Work Order ID 80170

Item ID: D3303-043 Accept *N9000040100* Setup Start *NS1*
 Revision ID: Stop *NS2*
 Item Name: Bracket Assembly
 Start Date: 13/02/2012 Start Qty: 2.00 *2* Cust Item ID:
 Required Date: 27/02/2012 Req'd Qty: 2.00 *2* Customer:
 Reference:

DESIGN <i>[Signature]</i>	DRAWN BY <i>[Signature]</i>	DART AEROSPACE LTD HAWKESBURY, ONTARIO, CANADA	
CHECKED <i>PH</i>	APPROVED <i>[Signature]</i>	DRAWING NO. D3303	REV. B SHEET 1 OF 4
DATE 06.08.17		TITLE HEAD REST	SCALE 1:3
REV	DATE	DESCRIPTION	
A	04.08.18	NEW ISSUE	
B	06.08.17	UPDATED FLAT PATTERN TO FORM PART IN ONE OPERATION USING OFFSET DIE

DRAWING NO. D3303	TITLE HEAD REST	REV. B	DART AEROSPACE LTD ENGINEERING ORDER		D.E.O. NO. D3303-B-1	SHEET NO. SHEET 1 OF 1	SCALE NTS
DRAWN AJS	CHECKED b	MFG. APPR. M	APPROVED MAD		DE APPR. H		
DATE 08.10.15	DATE 08.10.15	DATE 08/10/16	DATE 08/10/16		DATE 08/10/16

**D3303-041 HEAD REST**

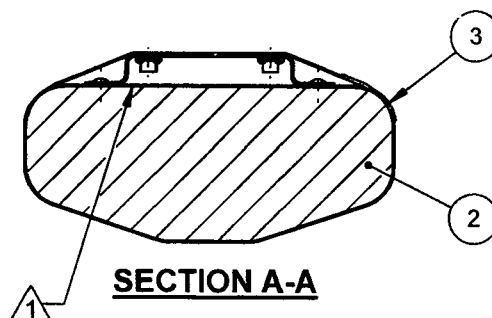
SHEET 1 ADD 1300L ADHESIVE BY 3M TO NOTE 1 AS FOLLOWS:

IS:

- 1) BOND D3305-1 FOAM TO D3303-043 BRACKET ASSEMBLY USING 3M 1300 OR 1300L ADHESIVE (0.002" TO 0.010" THICK) IN ACCORDANCE WITH MANUFACTURER'S INSTRUCTIONS

WAS:

- 1) BOND D3305-1 FOAM TO D3303-043 BRACKET ASSEMBLY USING 3M 1300 ADHESIVE (0.002" TO 0.010" THICK) IN ACCORDANCE WITH MANUFACTURER'S INSTRUCTIONS
